**New Mechanical Dimension (W19L300-PMM1):**

**Will be effective from 2010 / 01 / 15**

**Issued by: Winmate Communication INC.**

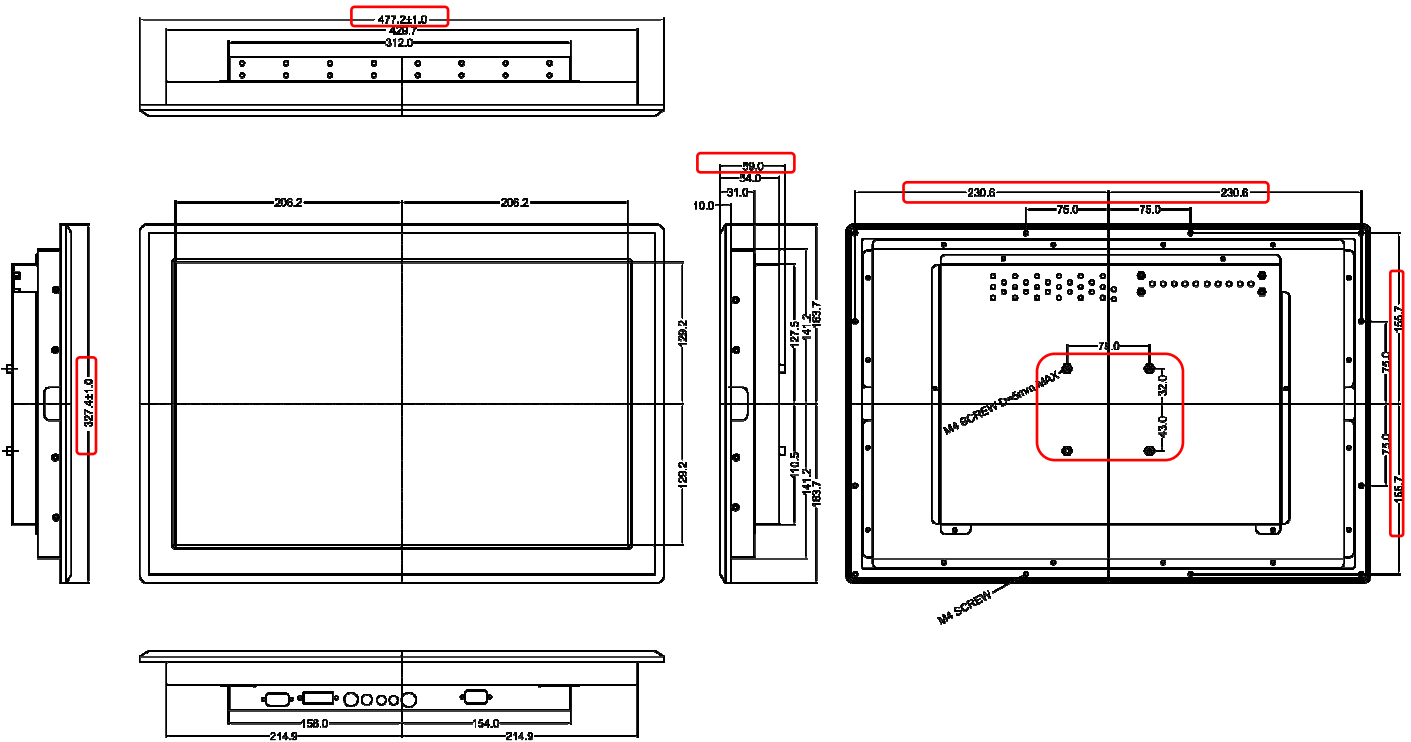
**Front side dimension change:**

- 1.length: 500mm(old) => 477.2mm(new)
- 2.wide: 360mm(old) => 327.4mm(new)
- 3.high: 68mm(old) => 59mm(new)

**back side dimension change:**

- 1.length: 308mm(old) => 312mm(new)
- 2.wide: 198.5mm(old) => 238mm(new)
- 3.high: 27mm(old) => 23mm(new)
